Recall Campaign Bulletin

Campaign No. 2021120004, December 2021

SUBJECT: **Model GLE-Class (167 platform)**
Model Year 2021
Electric Heater Ground Bolting

Figure 2

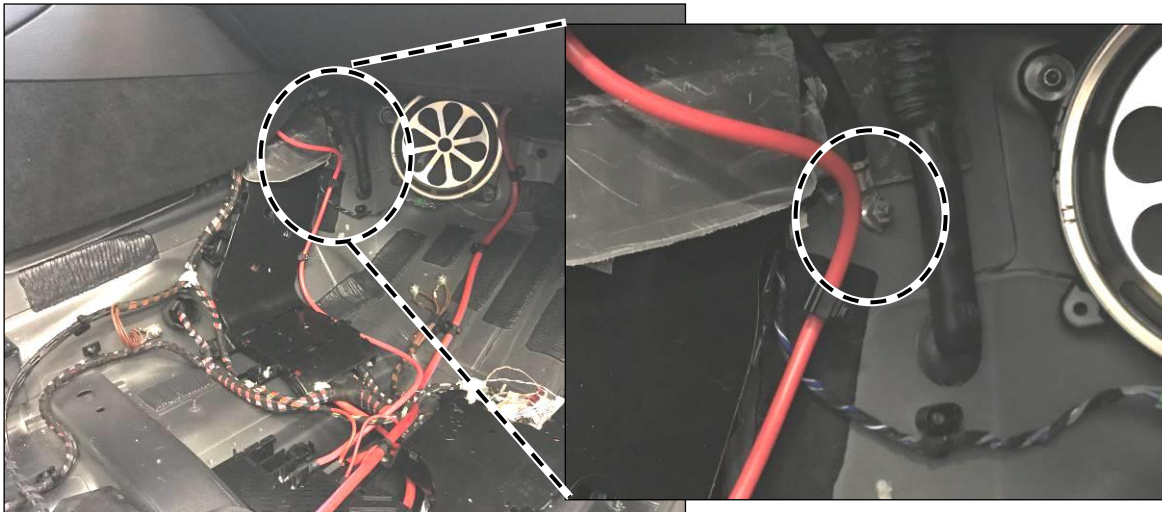
3. Check for scorch marks in area of ground connection of PTC booster heater (**Figure 2**).
4. Check ground connection of PTC booster heater as to whether loose or tightened with correct torque (**Figure 2**).

i **Figure 2** shown with removed floor covering!

i The torque of the ground connection **must** be **Nm** 10!

- a. **Scorch marks present** in the area of the ground connection:
Carry out **work procedure**.
- b. **Scorch marks not present** in the area of the ground connection:
End measure.
